WATERS Weekly FPY review (WW42 – 2018)

WAT-441001280 (Ethernet Cable, supplier CMTi)

CUSTOMER : FLEXTRONICS
PRODUCT NO. : 441001280 REV B
PART NAME : ASSY, CABLE, ETHERNET, 16 INCH
RE : Improvement proposal of bending position of RJ110C5S2

A – current bending point
B – proposed bending point

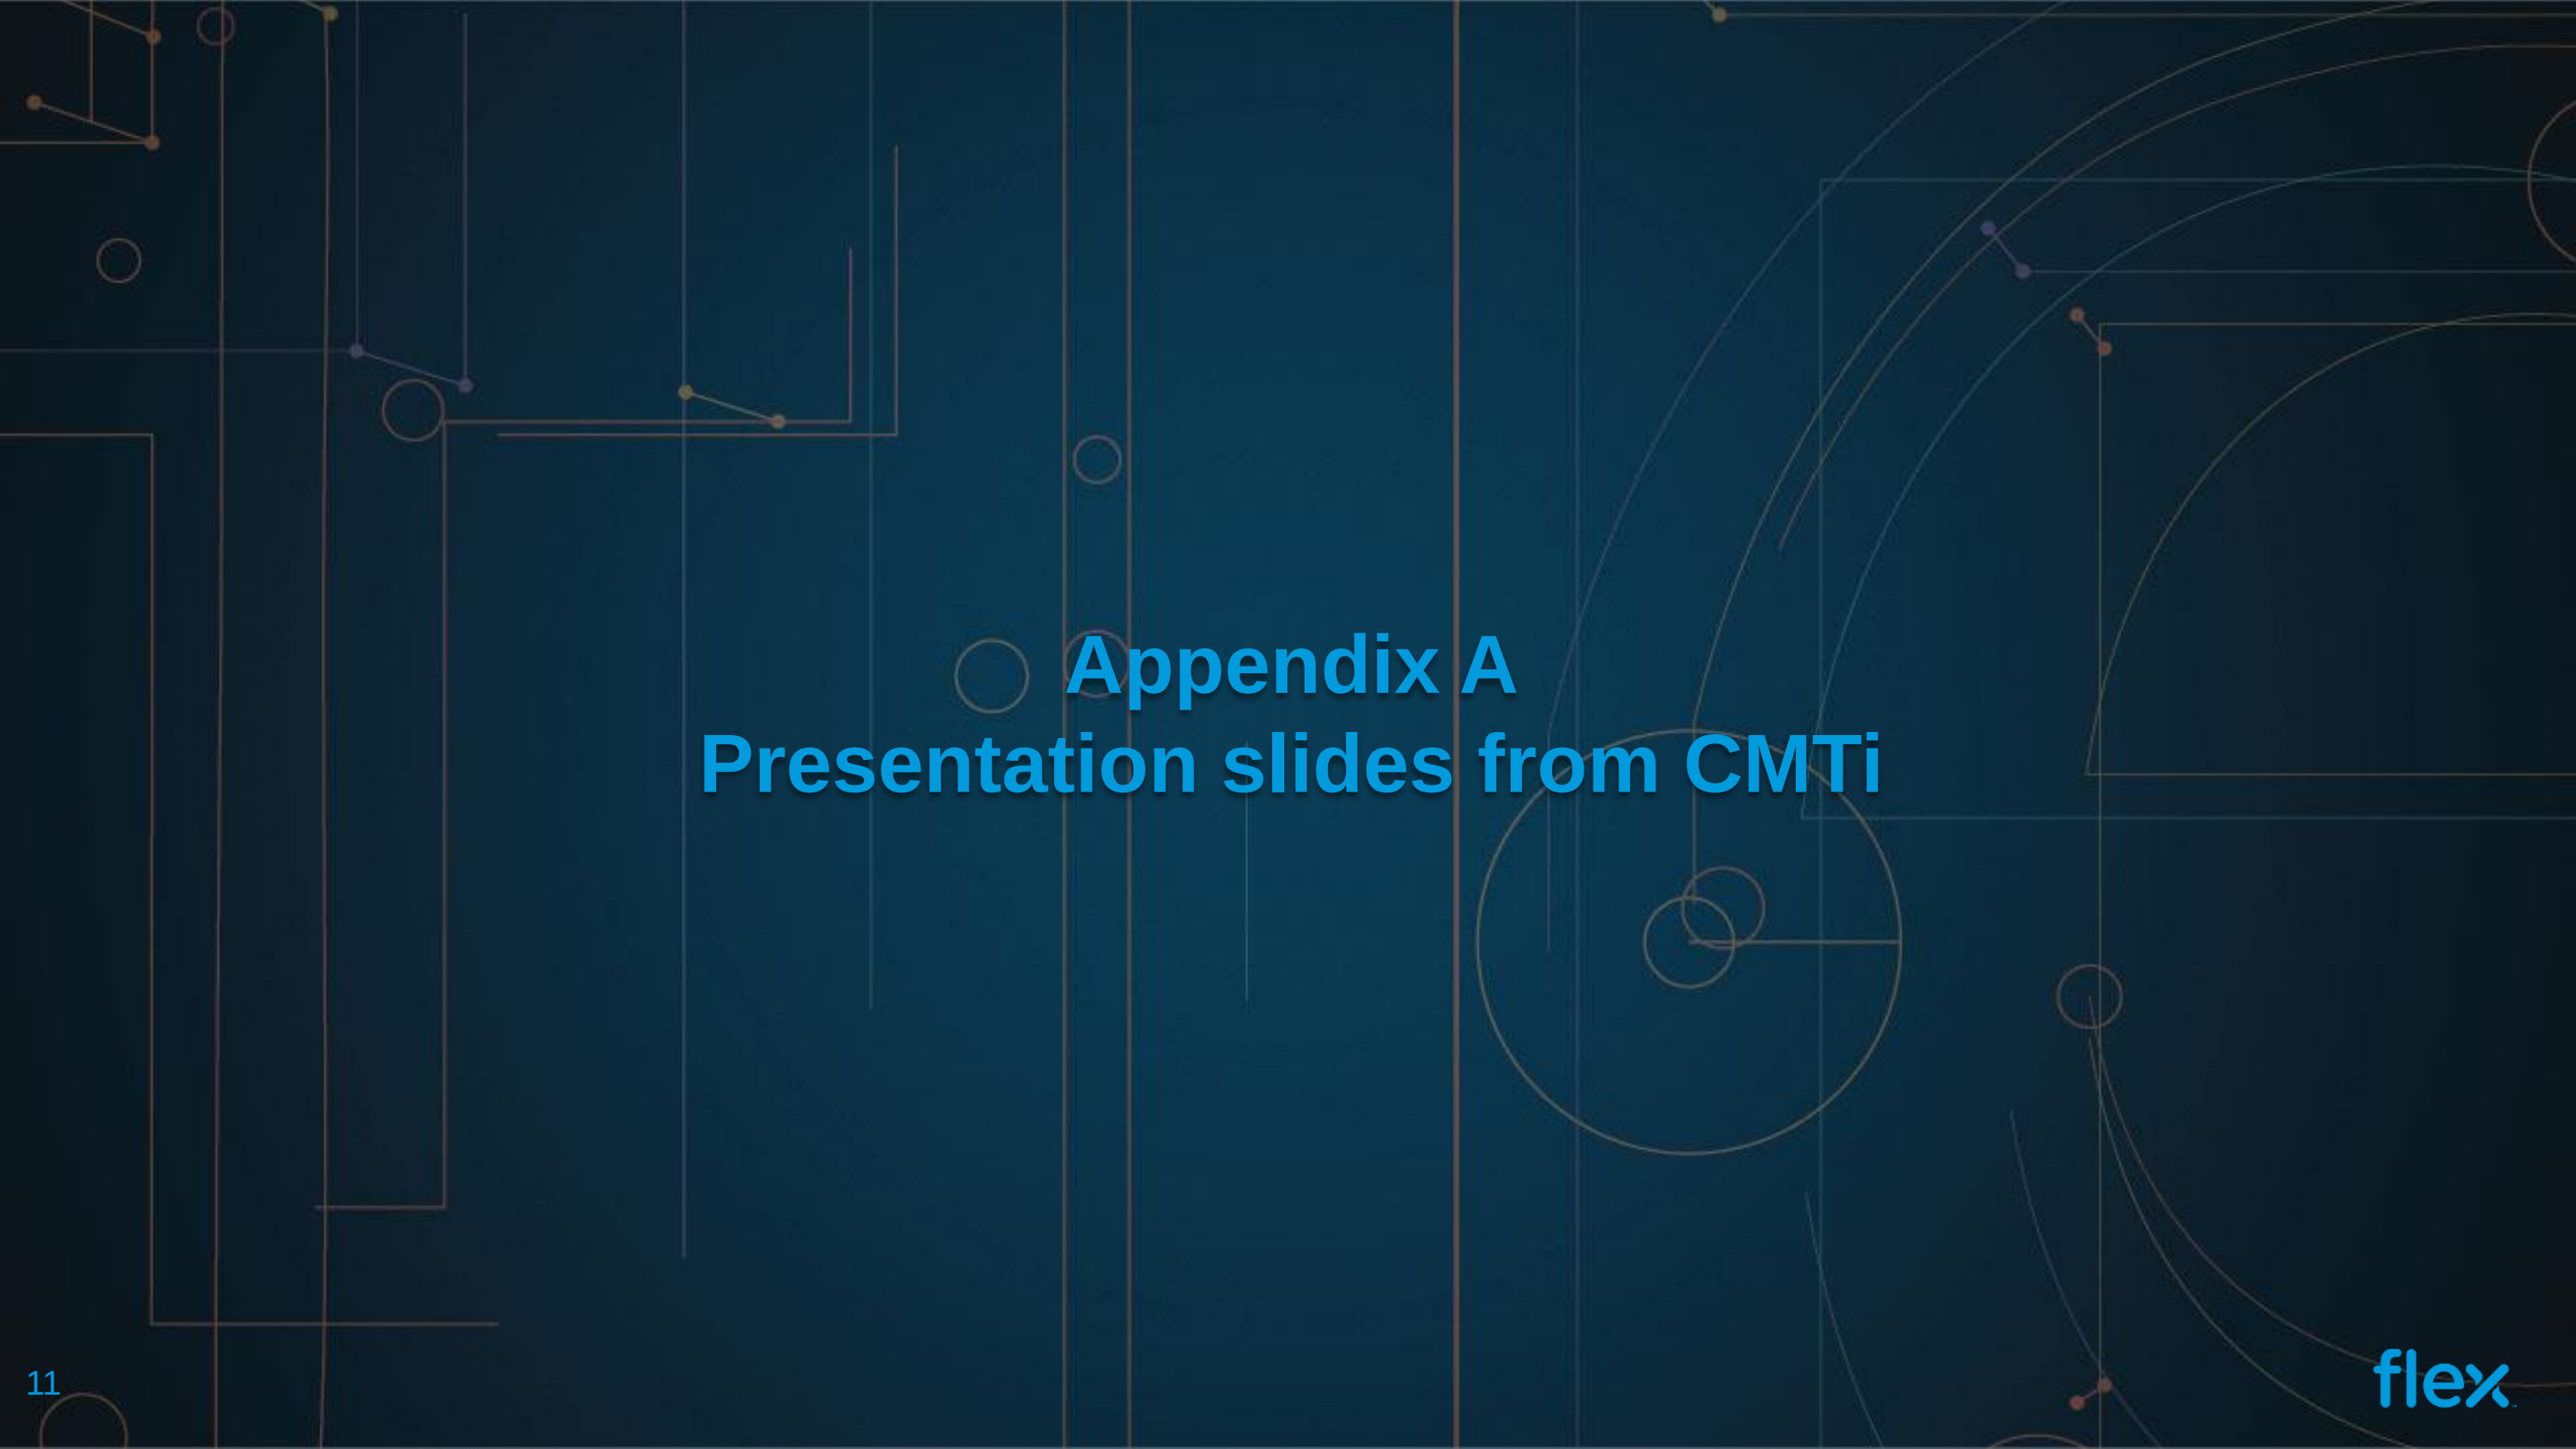
- CMTi reported that there is no failure reported at their outgoing since May 2017 (Qty tested: 9200 pcs)
- CMTi proposed to change the bending point.
- See Appendix A for more detail

Failed part

Raw part before bent

- There is no failure in Feb 2018 and Mar 2018 (Total > 600 instrument build)
- As the occurrence (Ethernet cable failing) is low and random, Flex does not recommend to go ahead with this change (Option A).
- Flex recommends to further monitor the yield and keeping this proposal as an option for future discussion.

Current bending method

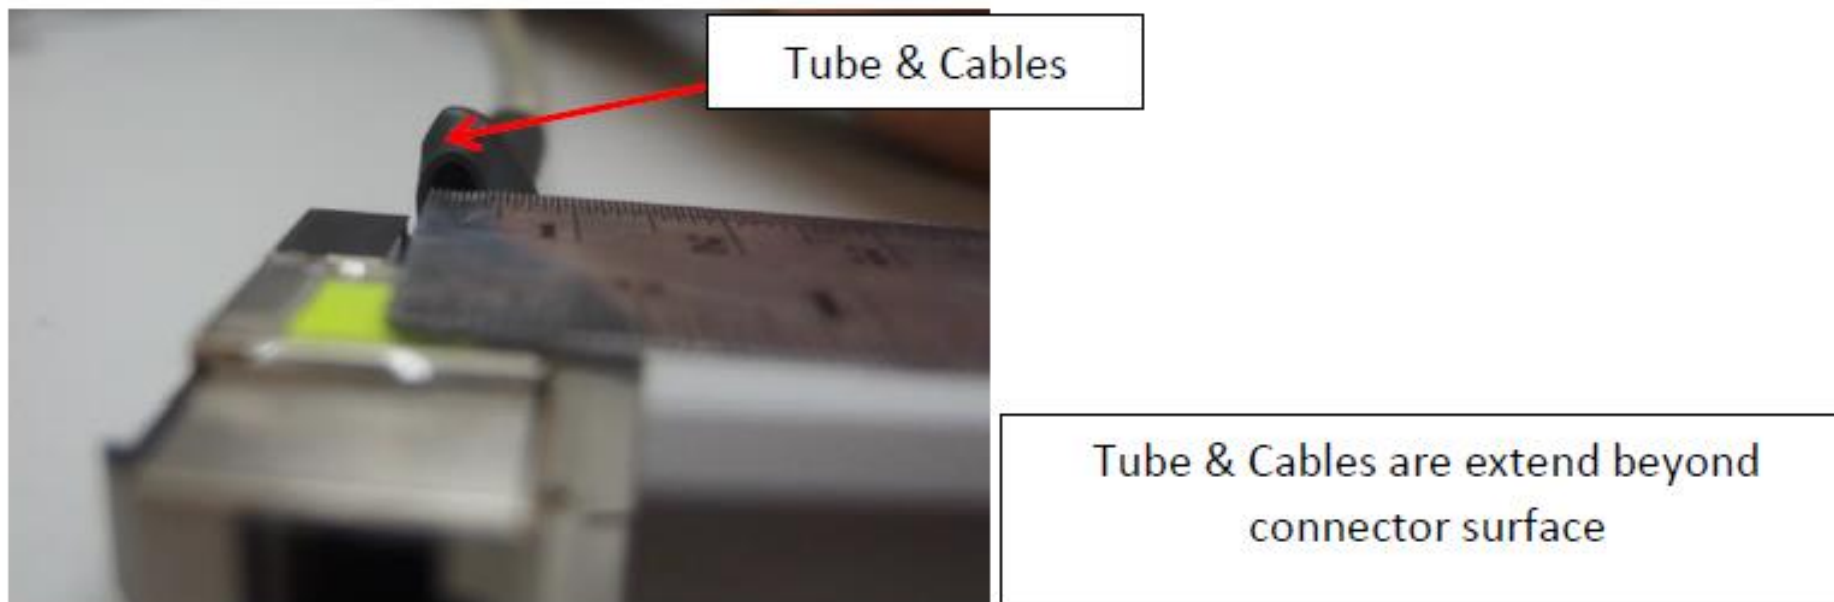
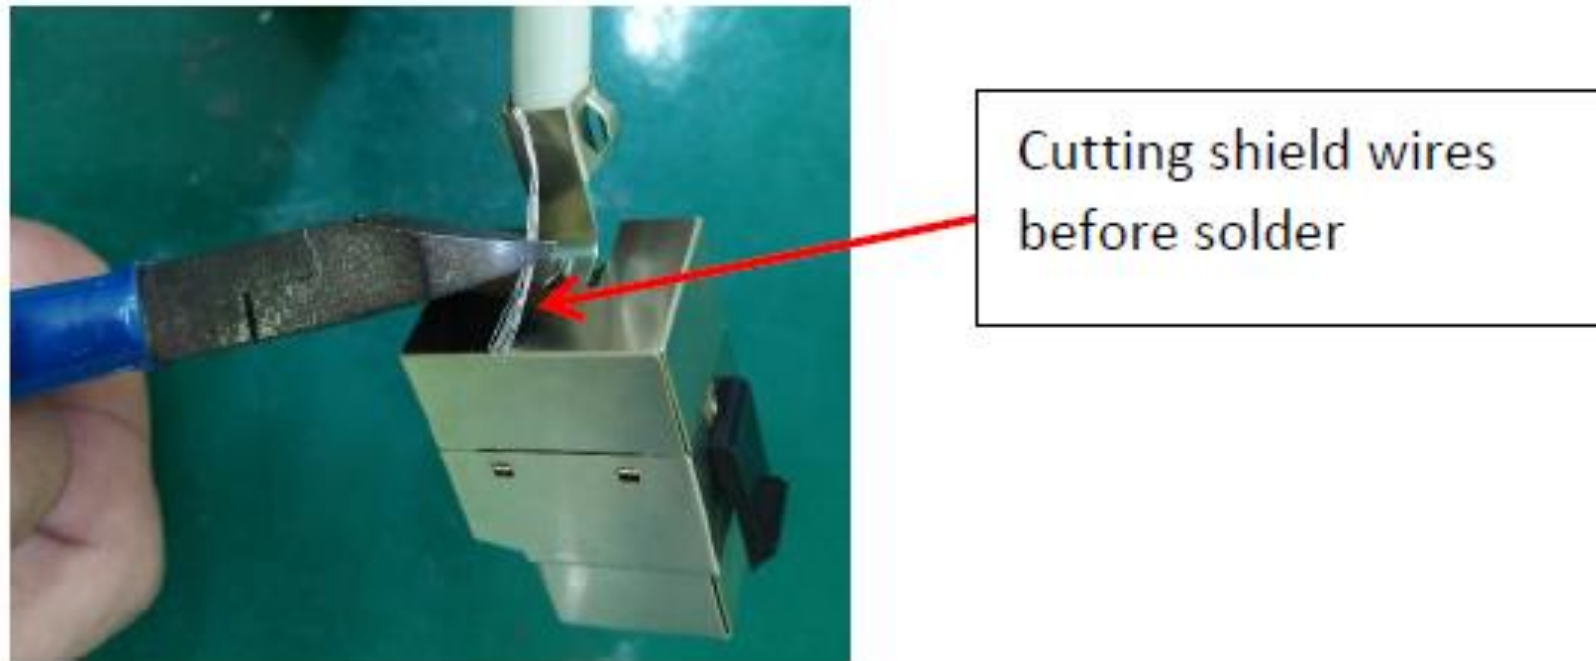
- ✓ Current bending method : Connector broken after 22 times bending
- ✓ Propose bending Method : Connector broken after 64 times bending

1. Propose bending method strength result is better than current bending method
2. Cable position of propose bending method is out of connector surface (refer to below picture for comparison)

3. There's additional cutting process for shield wire before solder to metal shield

4. Total Length of cables might sorter than current bending method. Therefore, we will conduct another simulation with actual product requirements when it's required.

- Propose bending method strength result is better than current bend method
- Cables & tube position are extend beyond connector surface might effect to form, fit
- There has additional cutting process for shield wire before solder
- Next simulation for total length of cables shall study if it's required.

01 Oct 2018 : response from Machine Shop, for info and discussion

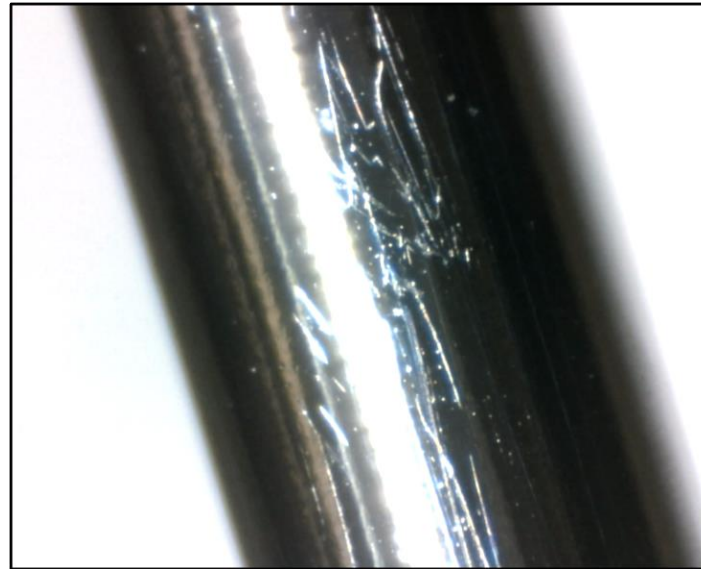
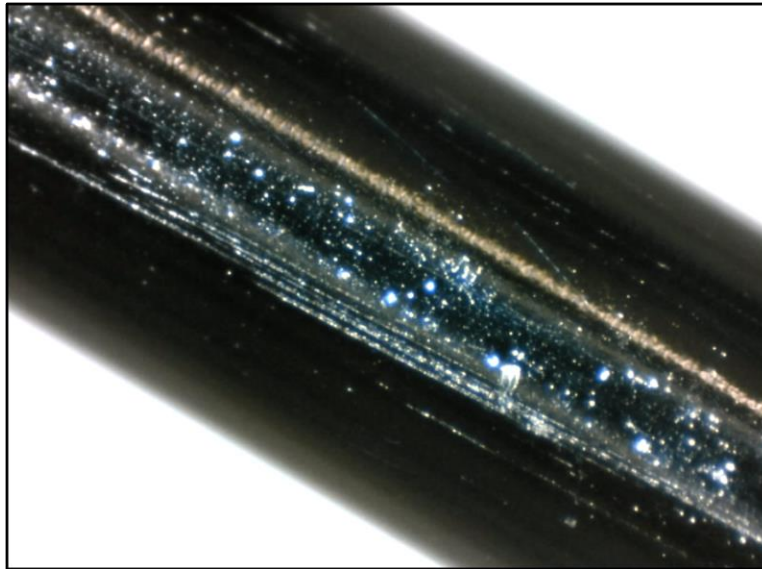
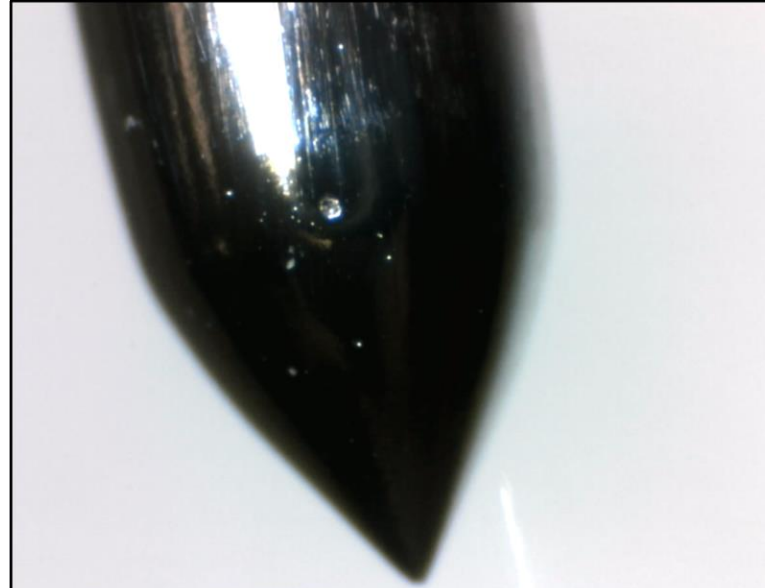
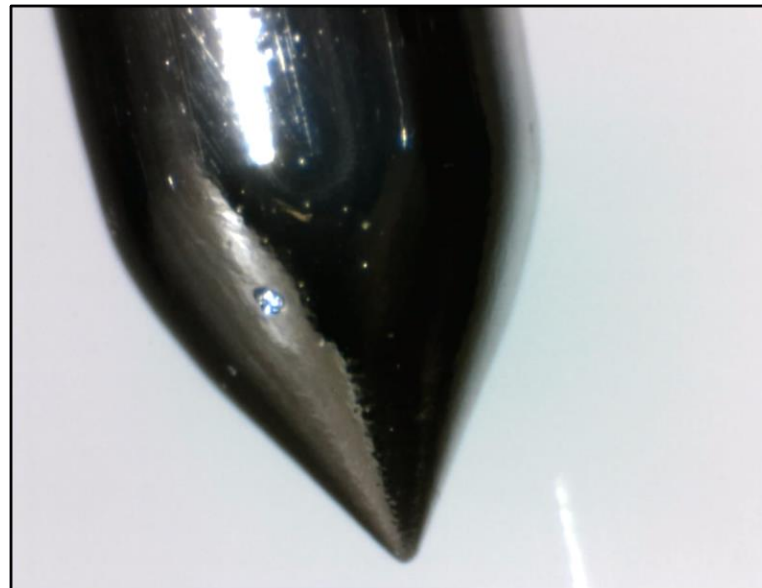
Scratches

Pits

Sample 1 (20x magnification)

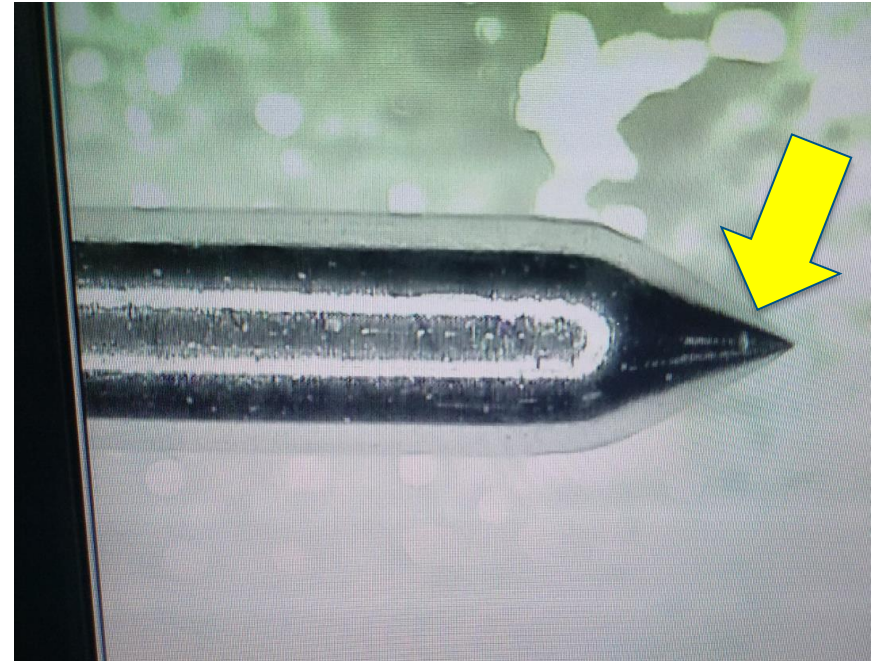
- Needle tip is checked for pit mark. A small pit mark was observed.

- Needle body is also checked for longitudinal scratches. No scratches found.

Sample 2 (20x magnification)

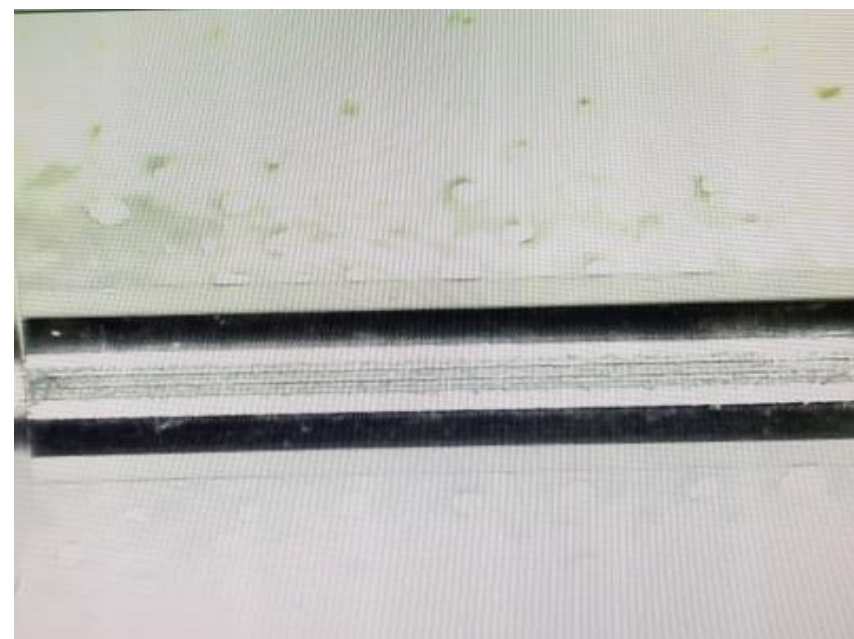
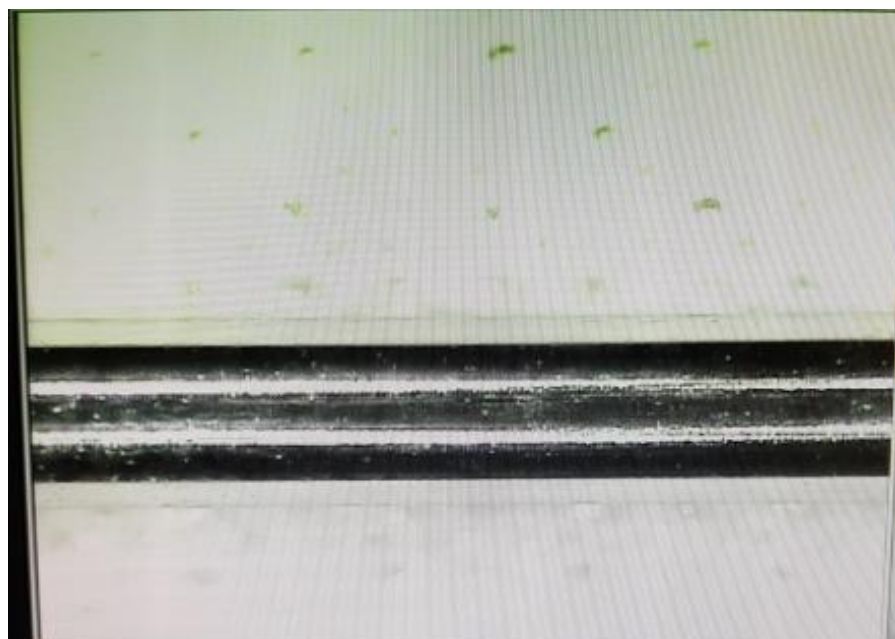
- Needle tip is checked for pit mark. Unable to detect pit.

- Needle body is also checked for longitudinal scratches. No scratches found.

Sample 3 (20x magnification)

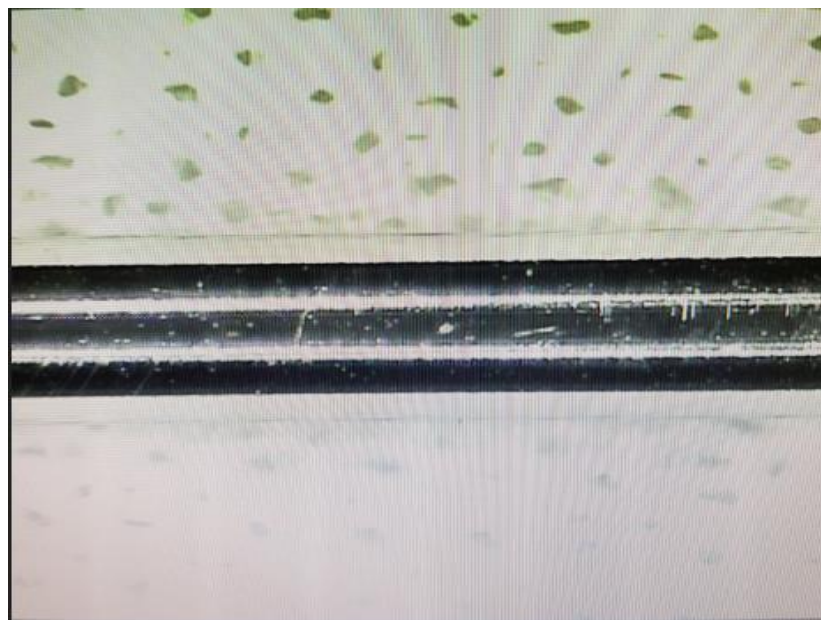
- Needle tip is checked for pit mark Unable to detect pit.

- Needle body is also checked for longitudinal scratches. No scratches found.
